**STATE OF NORTH CAROLINA  
UTILITIES COMMISSION  
RALEIGH**

In the Matter of )  
2025 Biennial Consolidated Carbon Plan and )  
Integrated Resource Plans of Duke )  
Energy Carolinas, LLC, and Duke ) Docket No. E-100, Sub 207  
Energy Progress, LLC, Pursuant to )  
N.C.G.S. § 62-2(a)(3a), 62-110.1, 62-110.9, )  
and Commission Rule R8-60A )

**DIRECT TESTIMONY OF  
JOHN MICHAEL HAGERTY**

**ON BEHALF OF  
CAROLINAS CLEAN ENERGY BUSINESS ASSOCIATION**

**FIGURE 6: SOLAR GENERATION VOLATILITY BY INSTALLED CAPACITY**

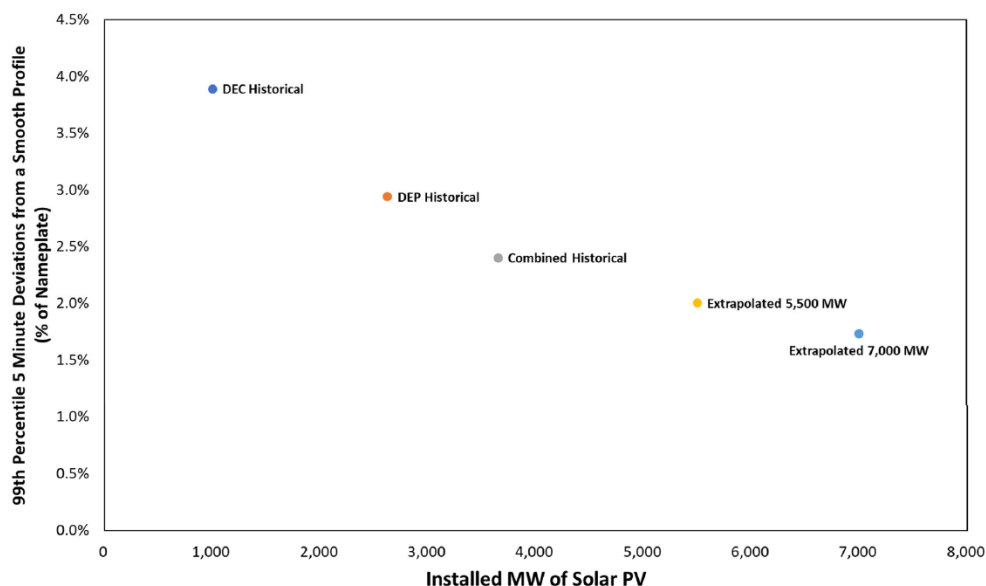
441                   |           Importantly, the 2023 SISC report finds that the volatility of generation  
442                   |           from installed solar resources decreases with increasing solar penetration, as  
443                   |           shown in Figure 6 below. Specifically, the figure shows that the amount of  
444                   |           deviations from a normalized profile decreases from nearly 4% at 1,000 MW of  
445                   |           installed solar capacity (blue dot labelled “DEC Historical”) to less than 2% at  
446                   |           7,000 MW (light blue dot labelled “Extrapolated 7,000 MW”).<sup>13</sup>

744 **FIGURE 12: 2040 SOLAR CAPACITY BY SCENARIO**

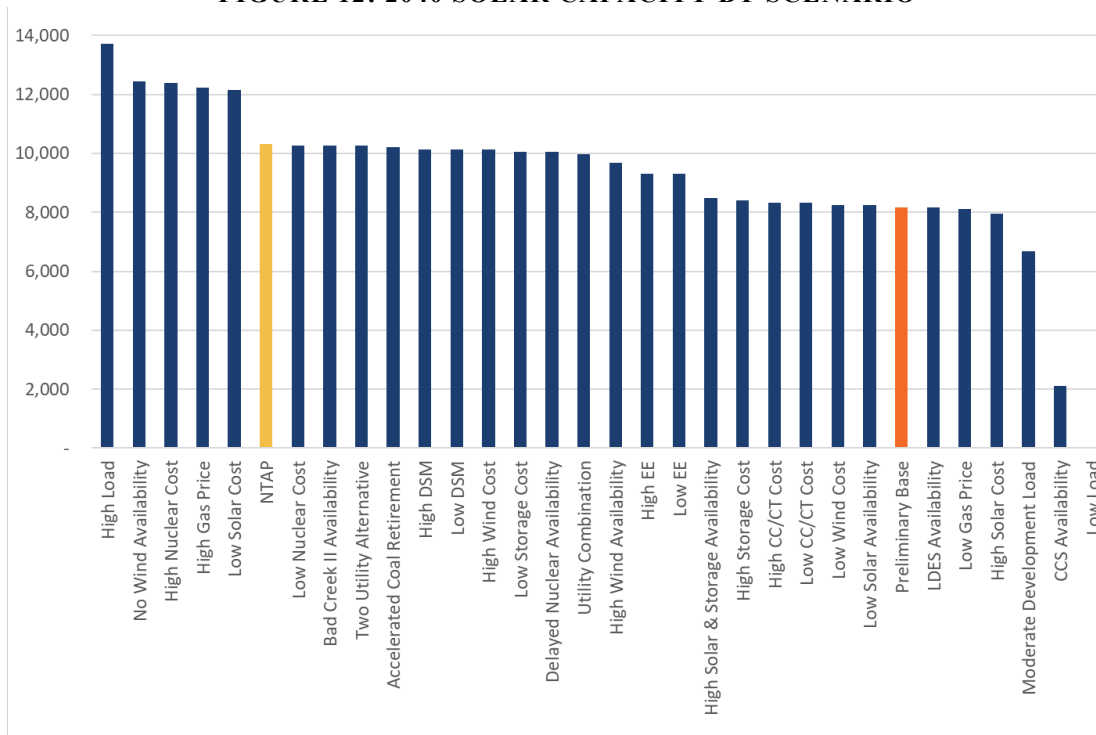
738 identified a wide of range of outcomes for future solar additions by 2040, ranging  
 739 from no additional solar in the Low Load scenario to nearly 14 GW in the High  
 740 Load scenario.<sup>32</sup> As shown in Figure 12, most of the scenarios add more solar  
 741 than the Base Preliminary case (orange bar). Reflecting the range of additional  
 742 solar capacity Duke identified across the scenarios, Duke included 10.3 GW of  
 743 solar by 2040 in the Near-Term Action Plan scenario (“NTAP”) (yellow bar).

FIGURE 16: MVST RELIABILITY-DRIVEN NEEDS

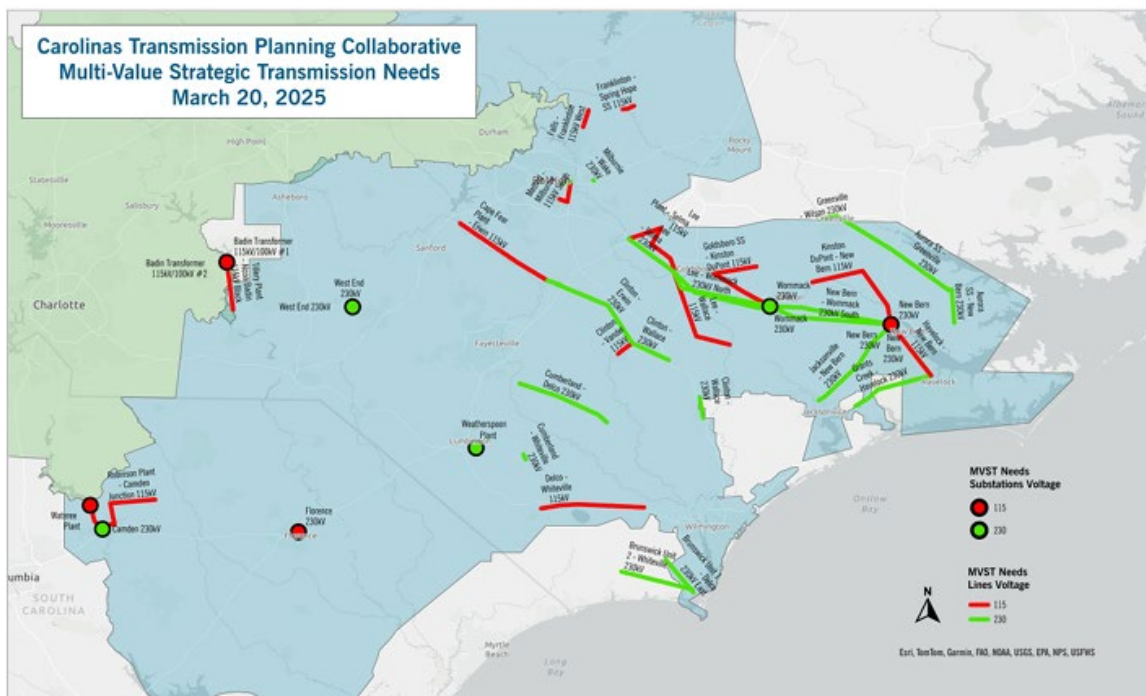
1110 A: Yes, the CTPC implemented the future scenarios into its local reliability planning  
1111 models to identify future reliability-driven needs. The CTPC identified significant  
1112 reliability violations on both the DEC and DEP systems, as shown in the maps  
1113 below. The CTPC prioritized the reliability needs based on a number of factors to  
1114 identify those that occur in the most scenarios and sensitivities and provide  
1115 capacity for interconnecting the most new resources. At the request of stakeholders,  
1116 the CTPC then identified specific clusters of violations to evaluate during the  
1117 solutions development step of the MVST study.
